MILLER UNION DEVELOPMENT
UNION ST, COOKS HILL. NEWCASTLE

APPENDIX E – Referral Comments

TO: David Paine
FROM: Alastair Peddie
DATE: 28 June 2011
SUBJECT: 121 Union Street, Cooks Hill (DA 10/1511)
Flood and Stormwater Management Assessment

SUBJECT: DA 10/1511 - TRAFFIC ASSESSMENT – 121 UNION STREET,
COOKS HILL – RESIDENTIAL FLAT BUILDING & BOARDING
HOUSE

Union St Link - Sectional Elevation

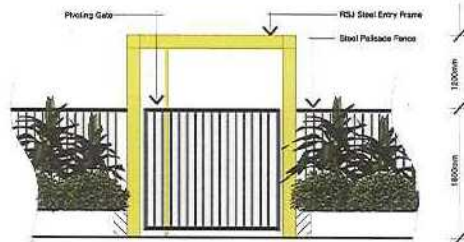
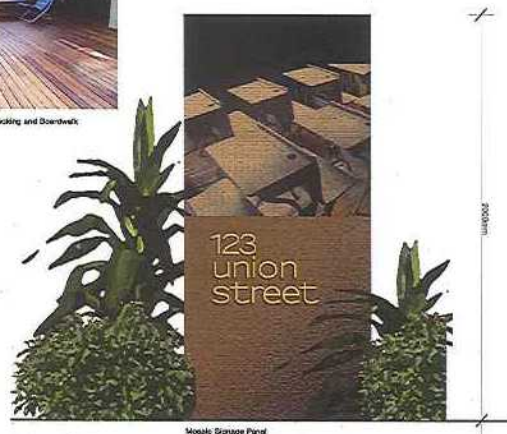
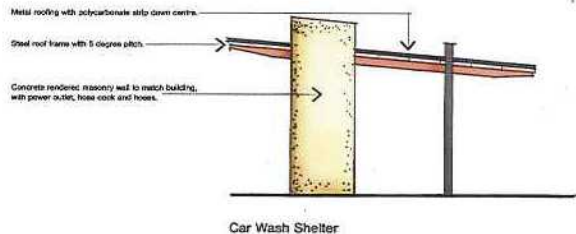
It was noted that a moderately large area between the western and central residential blocks which was capable of deep soil planting was finished with decomposed granite trafficable material. While some area is desirable for recreation spaces and

access, given the extent of hard surfaces because of the podiums above car parking, it was suggested that greater opportunity might be taken for quality deep soil planting in these areas of natural ground.
